PCN #: 2327 Rev 2 - (Final Notice)

PCN Title: Fab Porting from Global Foundries to MagnaChip, Assembly Site Transfer, and Bond Wire Change

PCN-2327 REV 2 - FINAL

New Top Marking

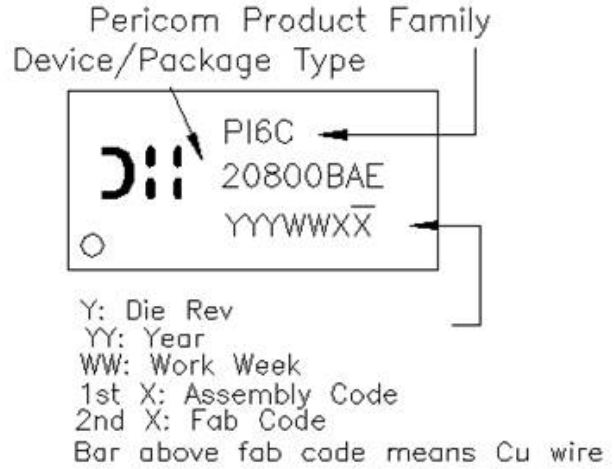
Notification Date:	Implementation Date:	Product Family:	Change Type:	PCN #:
April 20, 2018	November 11, 2020	Analog	Fab. Assembly and Test, Bond Wire Change	2327
TITLE				
Fab Porting from Global Foundries to MagnaChip, Assembly Site Transfer, and Bond Wire Change				
DESCRIPTION OF CHANGE				
<p>This PCN is being issued as a follow-up to the prior advance PCN to notify customers that Global Foundries in Woodlands, Singapore closed their 0.35um technology wafer production on December 15, 2018 and the parts listed in Table 1 are affected. Diodes will continue supporting orders for Global Foundries parts up to October 31, 2020 plus one (1) year for last time shipments.</p> <p>In order to ensure continuity of supply, Diodes will port affected products to Magnachip Semiconductor located in Heungdeok-gu, Korea using 0.18um technology. Assembly and test will also be transferred from OSE in Kaohsiung, Taiwan to Greatek Electronics Inc. in Miaoli, Taiwan. Bond wires will be changed from gold to copper wires. Any packages that have Pericom logo top marking will be changed to Diodes logo during the porting (see marking diagram below).</p> <p>Full electrical characterization and high reliability testing has been completed on representative part numbers. There is no change to device functionality or electrical specifications in the datasheet. Refer to the attached qualification / reliability report (embedded in this file).</p> <p>Rev 2:</p> <ul style="list-style-type: none">Added assembly/test site transfer, bond wire change, and top marking diagram.Several part numbers were removed from Table 1 (strike through text) since they have been discontinued (EOL) via PCN-2411 or PCN-2415 in the meanwhile.
